Project: IEEE P802.15 Working Group for Wireless Personal Area Networks (WPANs)

Submission Title: [Resolutions for new comments received after May 5 before May 9]

Date Submitted: [May 14, 2008]

# Resolutions for the new comments received before May 9

Figure 189

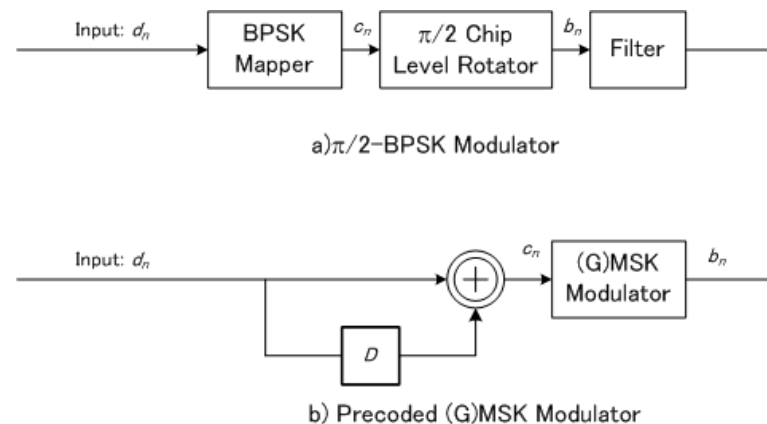
- Figure 189, more description in terms of equations is required to equate  $\pi/2$  BPSK modulator and GMSK modulator. For example initial phase of the chip level rotator. Also, the differential operation (xor) as currently specified is incorrect. If  $g_n$  is the input to the GMSK modulator then in the real field  $g_n = d_n \times d_{(n-1)}$  which is inverse of xor. In general, complete specification through equations would help rule out ambiguity
- Resolution: Accept the comment partially. Equations shown in the next slide shall be added to equate  $\pi/2$  BPSK modulator and GMSK modulator. Figure 189 shall be replaced as shown in the next slide.

## To be modified
